**SUBJECT: PALISADES NUCLEAR PLANT – STAFF ASSESSMENT OF RESPONSE TO
10 CFR 50.54(f) INFORMATION REQUEST – FLOOD-CAUSING MECHANISM
REEVALUATION (CAC NO. MF6128: EPID L-2015-JLD-0003)**

STAFF ASSESSMENT BY THE OFFICE OF NUCLEAR REACTOR REGULATION

PALISADES NUCLEAR PLANT

Figure 3.2-1. Map showing the key structures and identification numbers for the critical locations at safety-related structures of Palisades Nuclear Plant (Adapted from FHRR Figure 3.2-1). Locations are identified by numbers consistent with Table 3.2-1.

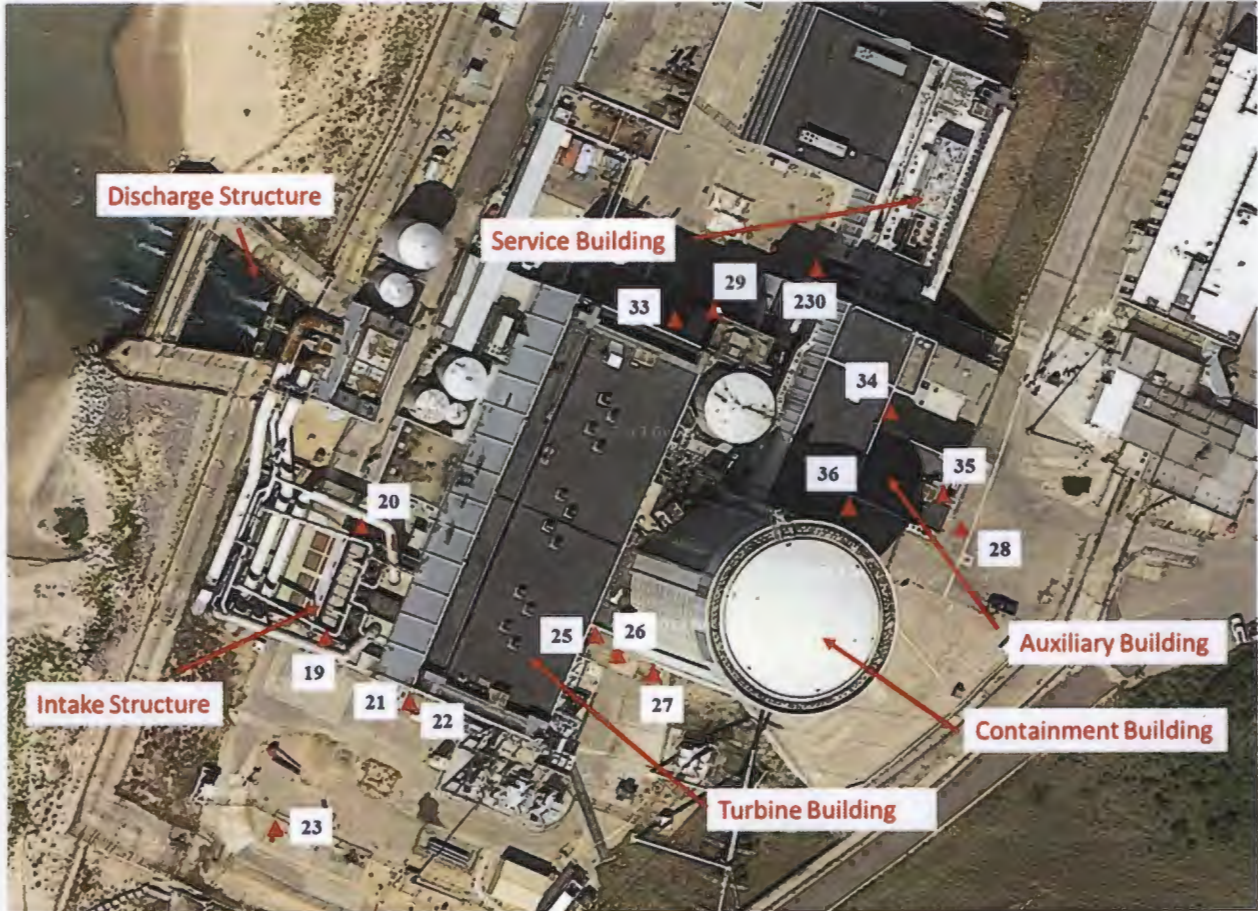
The model results for the LIP analysis indicate that the maximum WSEs at the Palisades site range from 592.5 ft. NGVD29 near the North Entrance to the Screen House/Intake Structure (See Figure 3.2-1; location 20) to 626.1 ft. NGVD29 at the Administration Building Hallway East Entrance (see Figure 3.2-1; location 35). The licensee evaluated 15 critical locations as shown in Figure 3.2-1 and found that most of them have maximum WSEs below the protection elevation of 594.4 ft. NGVD29, except for four that are located at ground surface above 594.4 ft. NGVD29. The maximum water depths at these four locations ranges from 1.0 ft. to 2.2 ft.

The simulated maximum flood depths are 9.8 ft. on the east side of the Service Building and 1.0 ft. to 5.3 ft. in the rest of the powerblock. The CDB for LIP event includes maximum flood depths of 5 ft. on the east side of the Service Building and less than 0.5 ft. in the rest of the powerblock. On the basis of maximum flood depths computed from the FLO-2D model, the reevaluated LIP flood hazard is not bounded by the CDB.
